DELHI DEVELOPMENT AUTHORITY (MASTER PLAN SECTION)

Minutes of the 82th meeting of Technical Committee held on 12.11.97 at 10.00 A.M. in the Conference Hall, 5th floor, Vikas Minar, IP Estate, New Delhi.

DELHI DEVELOPMENT AUTHORITY (DEV. CONTROL & BUILDING)

MEETING NOTICE

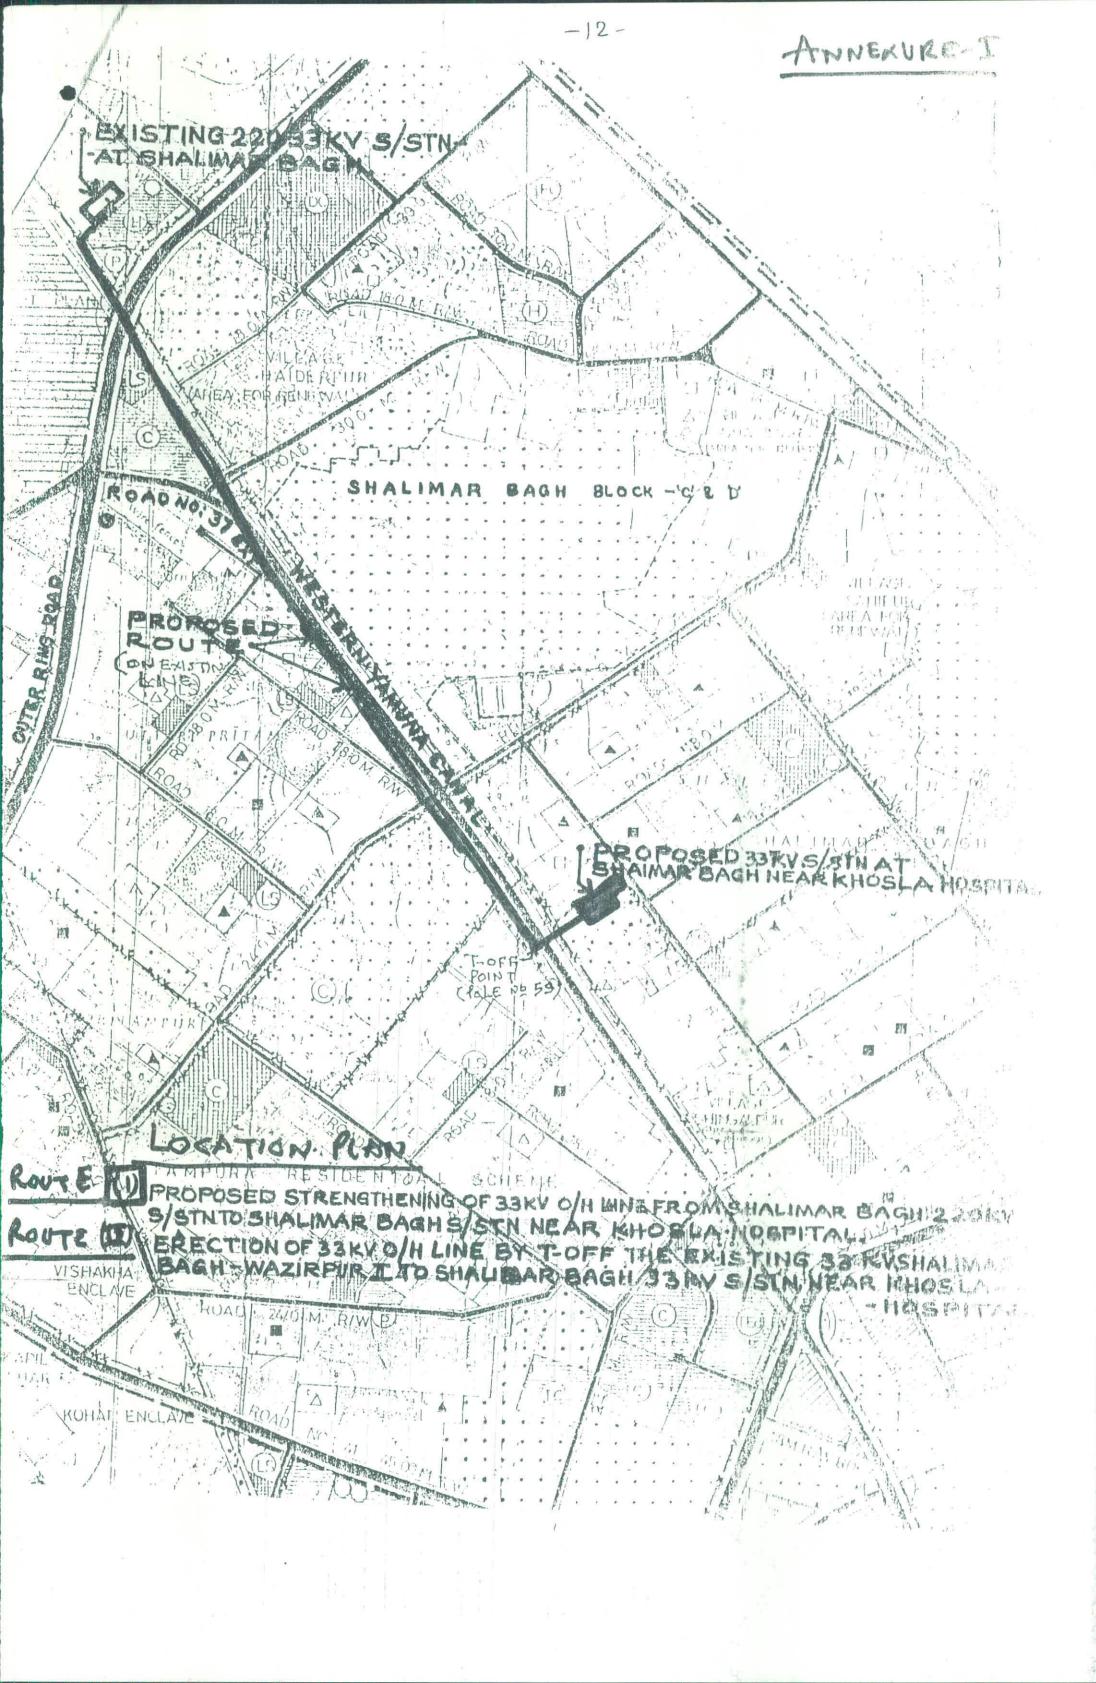
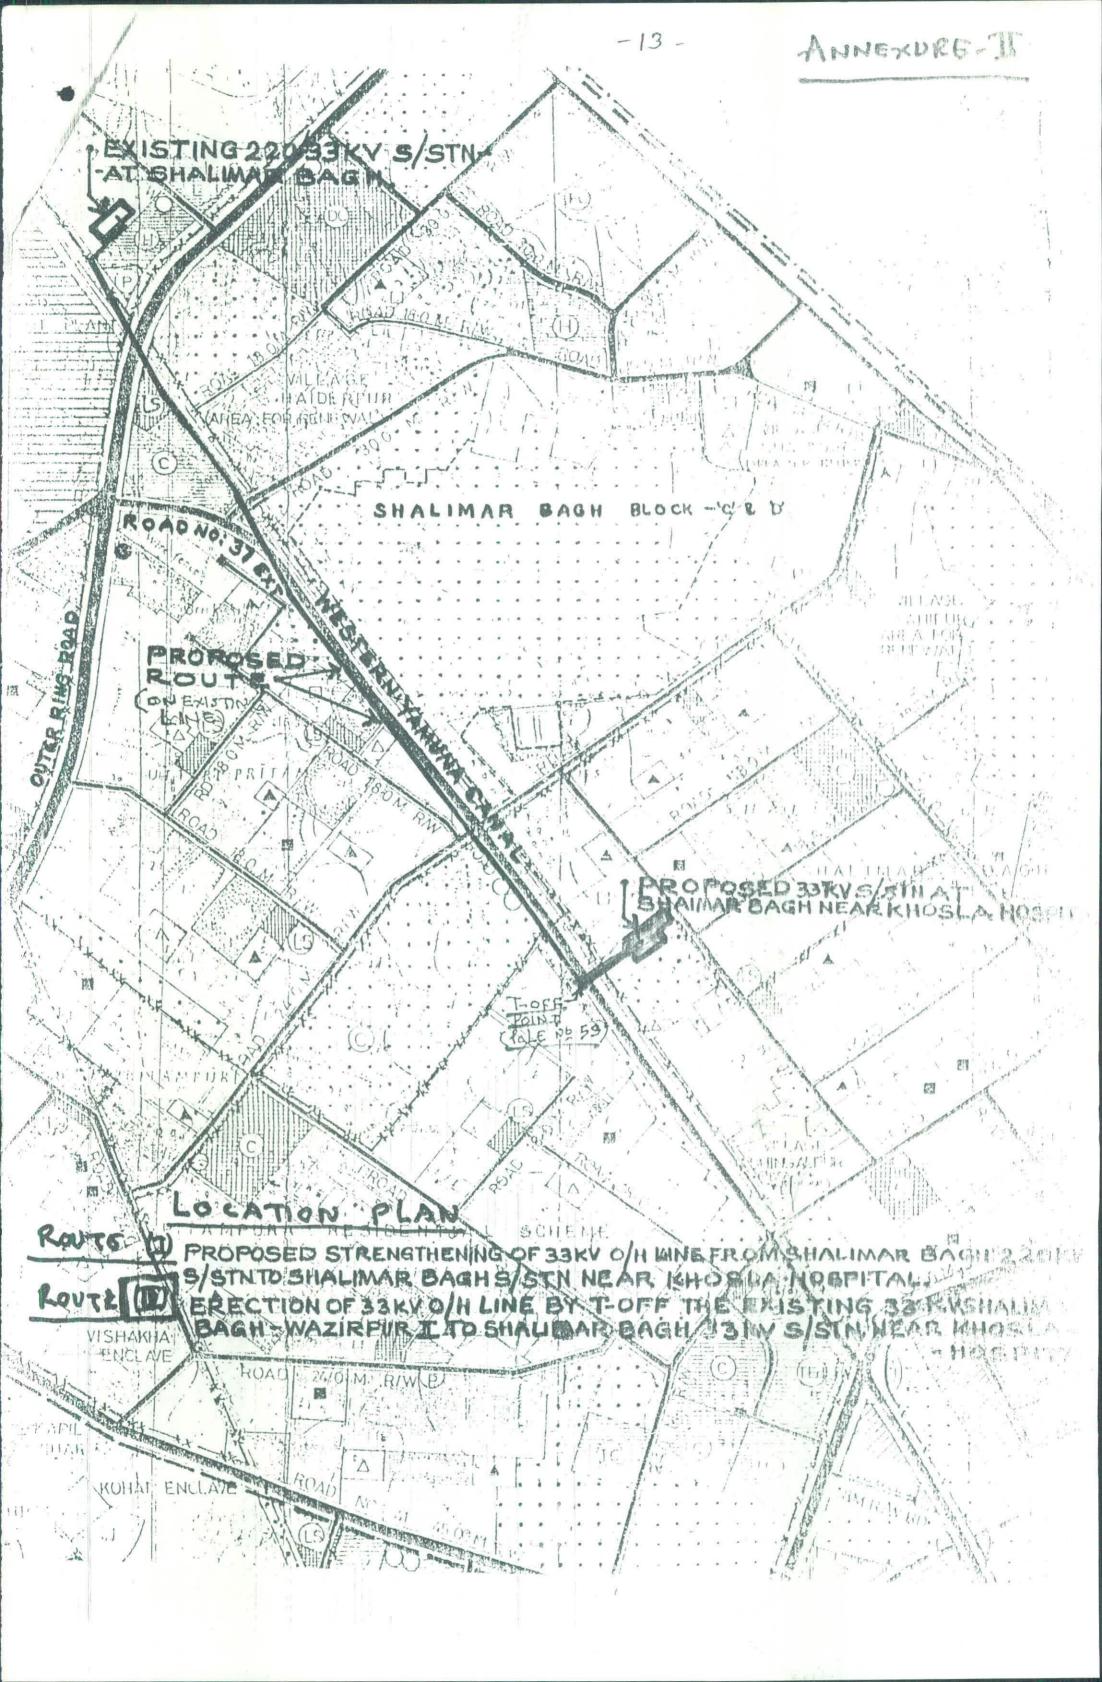
From the Survey Plan & alignment Plan it has been notic with that existing poles of O/H 33 KV line are existing in rig zag manner & some are with proposed Footpath/maincarriage-way and some are even out of the right of way line. The case was discussed with Ex. Eng. DVB. DVB has agreed to modify the existing poles according to mignment plan.

The disc ssions with DVB Officers indicate that proposed 2nd pole shall be at a distance of 1.8 mt.from existing/modified pole & other will be a projection of about 0.9 mt. on each side of the route. This will make the total width of the route as 4 mtr.(approx.). Thus the total width of the footpath shall have O/H 33 KV lines.

The Planning Wing is of the opinion this shall not be desireable as pedesorains psycologically will feel to the also such throposal shall close the option for the plantation etc. on the footpath. It is suggest that route be taken as underground for the

Route-II: In this proposal, the proposed H.T.

Poles shall be erected in consultation with the concerned Deptt, in such a way that no tree shall be affected.

As per the feasibility report sent by the EE, DVB vide letter dt. 29.7.97 that no tree structure is affected in the proposal.

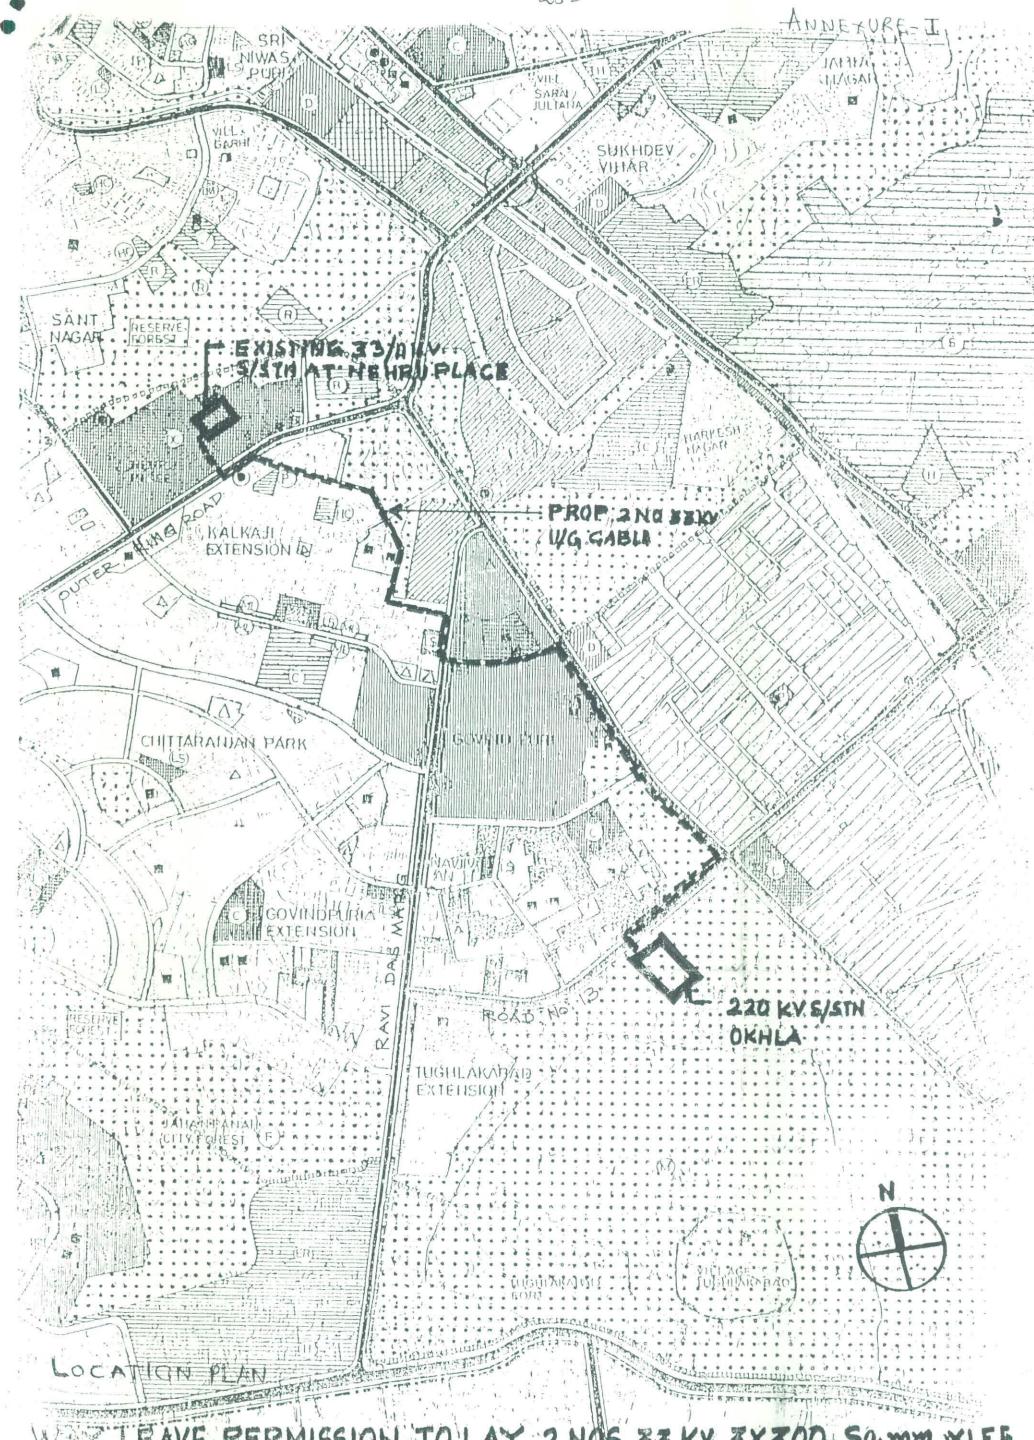
The route has been proposed below the Foot Path of the Master Plan/Zonal Plan Roads and the Internal Roads of Malkaji and Nehru Place Distt. Centre. On Ravi Dass Marg the proposed route (cables) in the Cycle Track portion as per the standard cross section of the road. The detailed observations with recommendations has been placed at Ann. II.

The route proposed by DVB as explained in Para 2 above with the following modifications and actions:

- a) On Ravi Dass Marg, the underground cables be laid below the 1.52 metwo wide Outer Foot Path as per the standard Road section of 30,48 meter (100 ft.) R/W.
- b) The DVB shall obtain permission from the other concerned agencies before carrying out the implementation of the scheme.
